**NORTH WELD COUNTY WATER DISTRICT**

**Notice of Meeting**

**Tuesday, September 3, 2024, at 8:30 AM**

# Work Change Directive

CR3 Connection at  
STA 241+50

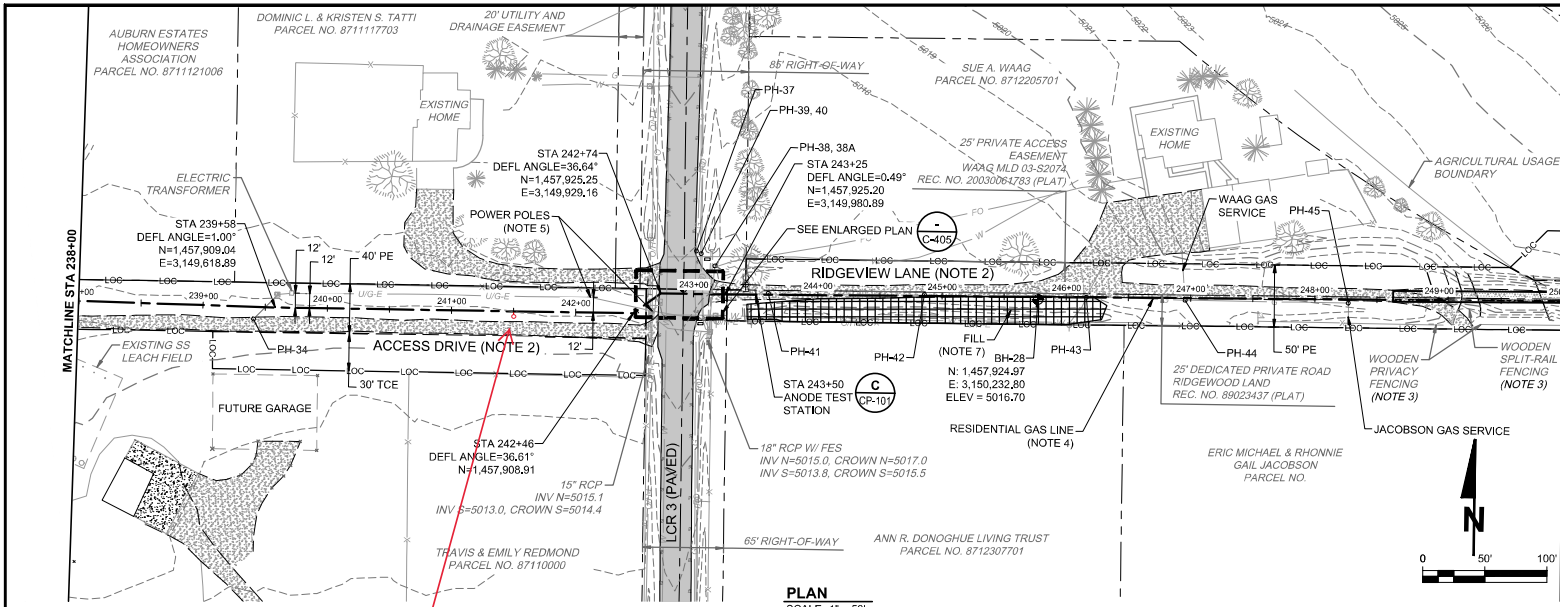
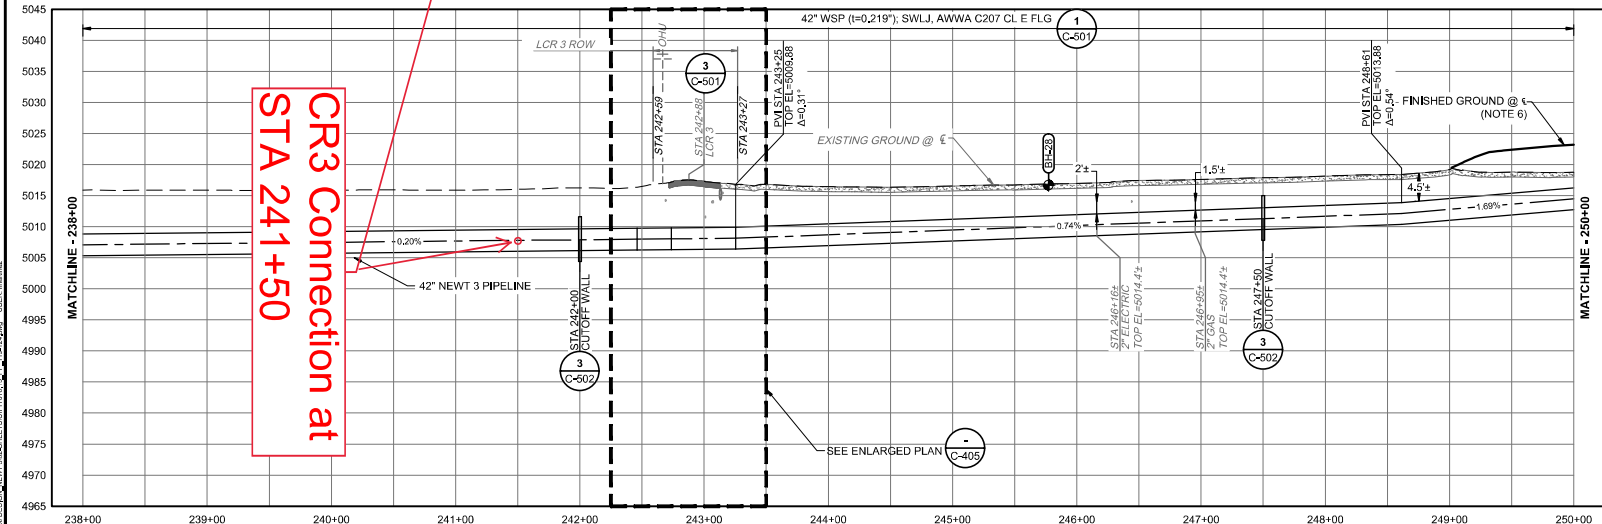
Contractor is directed to proceed promptly with the following change(s):

### PURPOSE FOR THE WORK CHANGE DIRECTIVE

As has been discussed at recent Project meetings ELCO is proposing to add a connection to NEWT III at CR3 (“CR3 Connection”) and include that work as part of the Project. The CR3 Connection will be of the same design as the above noted CR5 Connection as well as another connection that is part of the Project at County Road 1 (“CR1”) and consist only of the 16” outlet/weldment, a 16” butterfly valve and a plug. The location of the CR3 Connection is shown on Exhibit 2. With Exhibit 2 I have also included the outlet/weldment design drawing, the

3 WSP OUTLET DETAIL  
SCALE: NTS

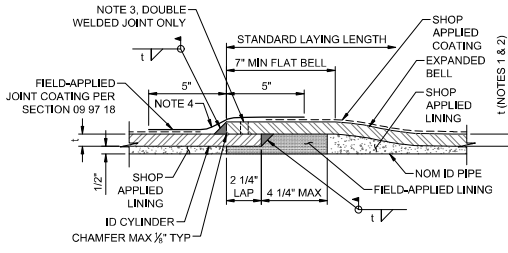
To clarify, you want me to find the price of what it would cost for us to send you a ship loose 16" outlet with a class E flange welded on it? Do you want me to include the reinforcement welded onto the outlet?

Can you get me a price to add a weld on 16" outlet onto this pipe ? Exactly like the one that is at station 189+70.
